Instruction Sheet of Delacamp HP9000 Mag Roller New Contact Plate and Delacamp HP9000

New Contact Plate for Old Style End Cap

HP9000 Mag Roller New Contact Plate	HP9000 New Contact Plate for Old Style End Cap

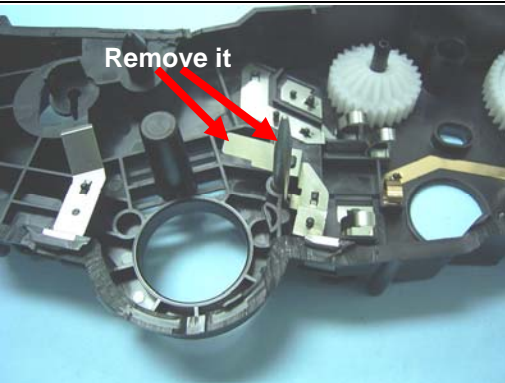
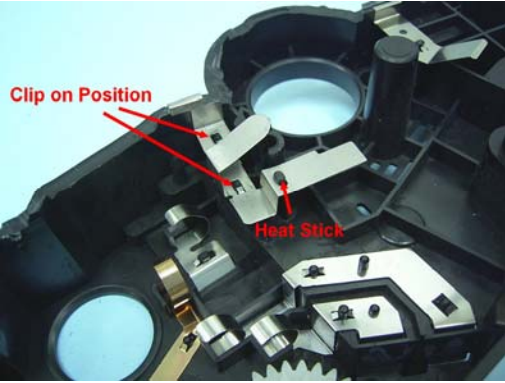
The Old Style Mag Roller Contact design in the HP9000 Cartridge can cause intermittence printing due to bad conductivity between the Mag Roller and the contact in the end cap. The new HP9000 has a revised design and New Style Mag Roller Contacts and End Cap Contact Plate to solve the problem. Delacamp has developed the HP9000 Mag Roller New Contact Plate and HP9000 New Style Contact Plate for converting the HP9000 Old Style End Cap to have the New Style Contact design.

<p><u>Step 1</u> Remove the Old Style OEM Contact Plate and the Contact Pin from the OEM HP9000 Old Style Right End Cap.</p>
	<p><u>Step 2</u> Assemble the Delacamp HP9000 New Contact Plate on the OEM HP9000 Right End Cap and clip into the location provided.</p>
	<p><u>Step 3</u> Assemble the Delacamp HP9000 Mag Roller New Contact Plate into the Mag Roller and add some conductive grease on the surface of the Delacamp HP9000 Mag Roller New Contact Plate. Reassemble end cap onto cartridge.</p>
